## REVISED IGNITION TIMING — 1000 / 1340cc

Figure 1. Prestolite Timer and Flywheel Timing Marks

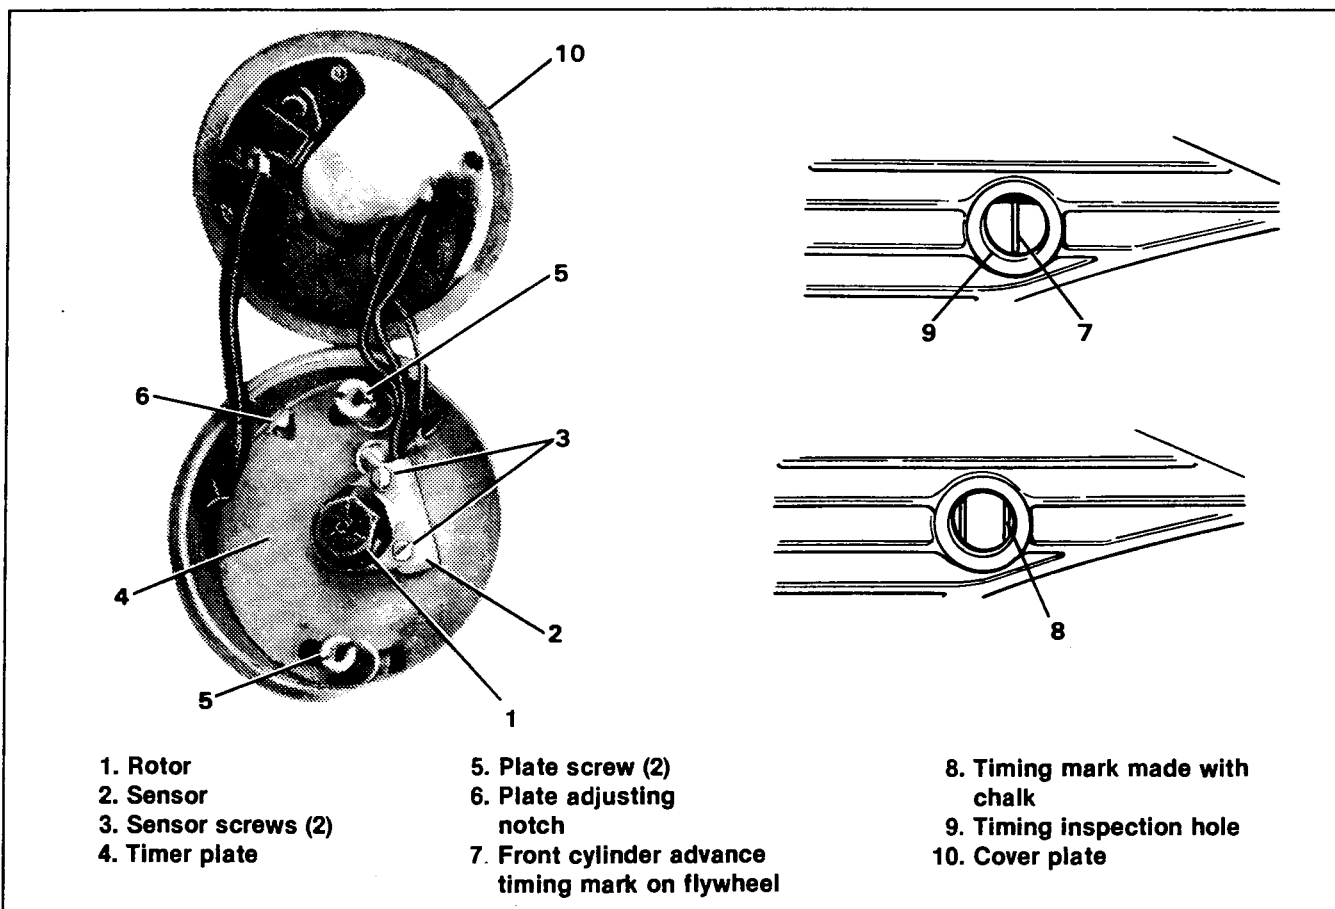
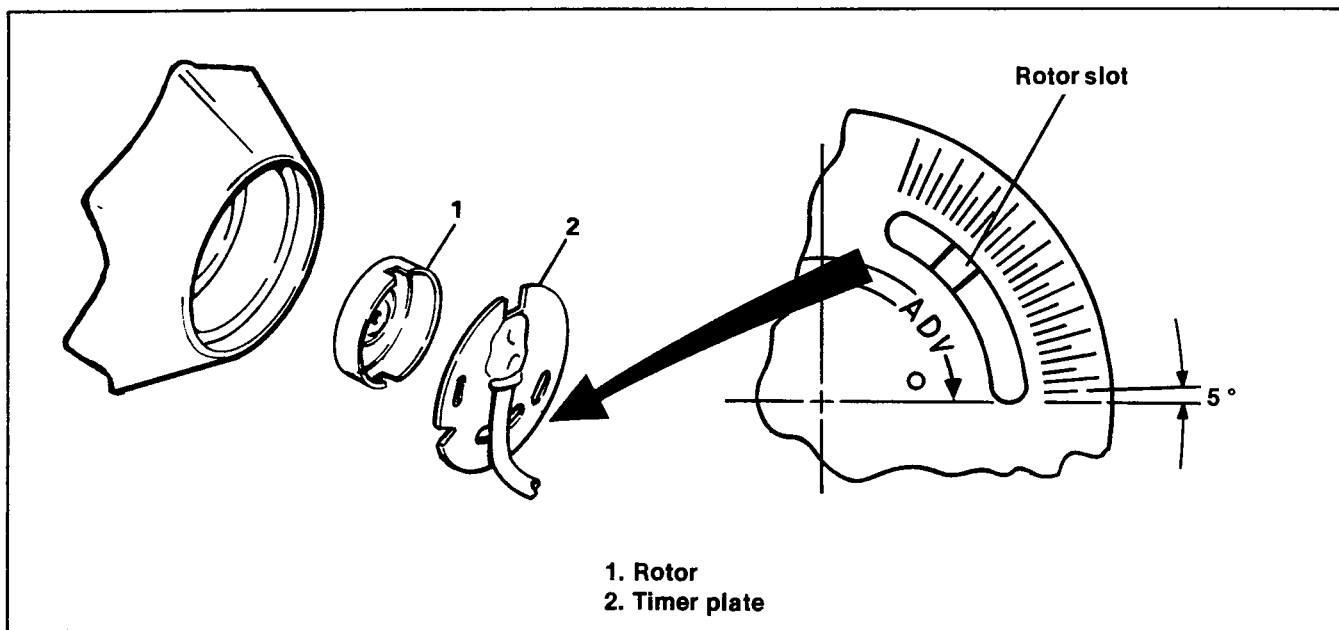
1. Check the ignition timing as described in the Service Manual under CHECKING ADVANCE TIMING WITH STROBE TIMING LIGHT. Set the timing if necessary.
2. See Figure 1. Turn the engine over until the timing mark (7) is at the extreme front edge of the timing hole (9).
3. Make a new timing mark (8) with a piece of chalk at the extreme rear edge of the timing hole.
4. Start the engine and set the idle speed at 2000 rpm. Retard the timing by shifting the timer plate (4) so the new timing mark (8) moves toward the front of the timing inspection hole. The timing advance should only be reduced in 2½° increments and on-
